5.2 Integrity of Reactor Coolant Pressure Boundary

The information in this section of the reference ABWR DCD, including all subsections, tables, and figures, is incorporated by reference with the following departures and supplements.

Figure 5.2-2 MSIV Closure with Flux scram and Installed Safety / Relief Valve Capacity

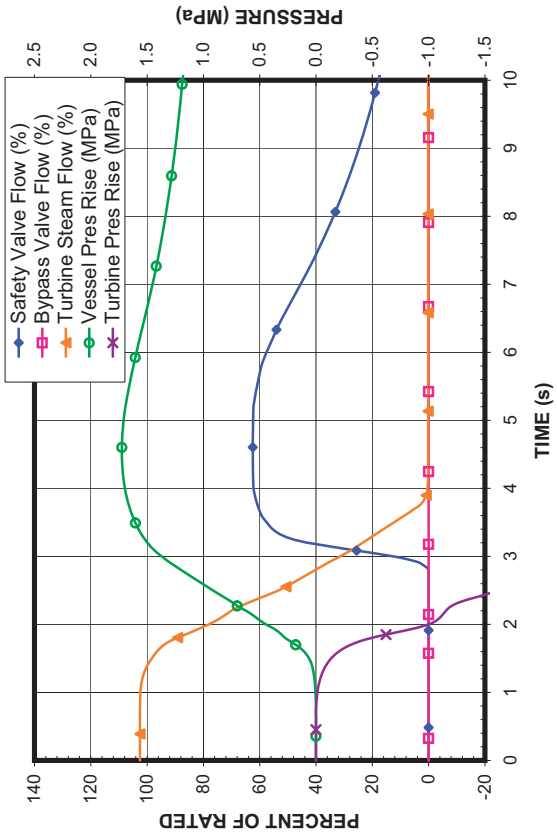
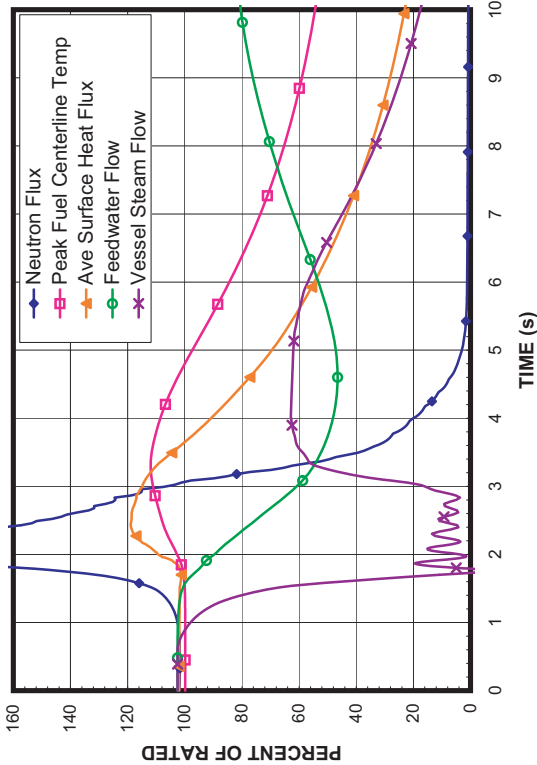
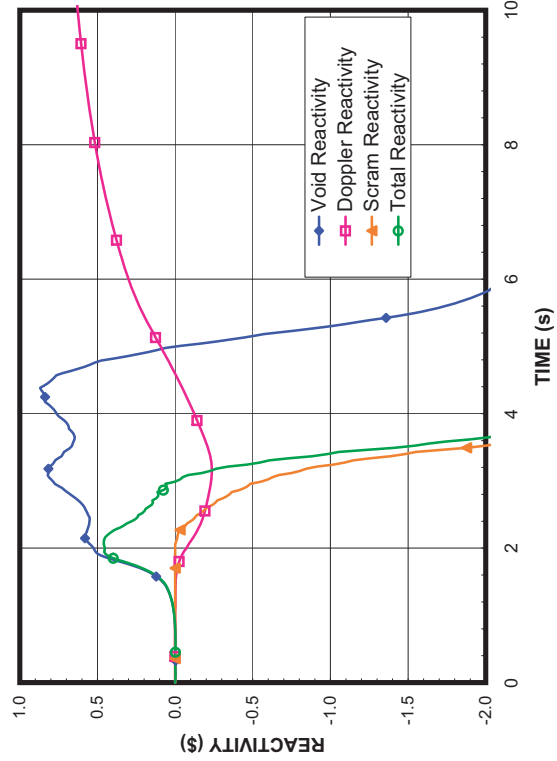
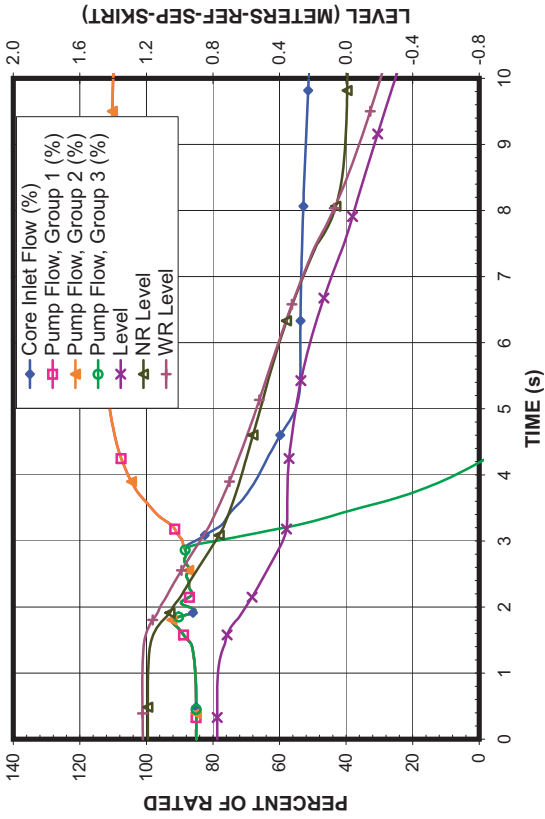
STD DEP T1 2.1-1 (Table 5.2-3, Figure 5.2-2, replaced entire figure)

The required SRV capacity is determined by analyzing the pressure rise from an MSIV closure with a flux scram transient. Results of this analysis are given in Figure 5.2-2. The peak vessel bottom pressure calculated is ~~8.79~~ 9.09 MPaG, which is well below the acceptance limit of 9.48 MPaG. The results show that only 12 valves are required to meet the design requirement with adequate margin. The analysis assumes one of the 12 SRVs fails on demand.
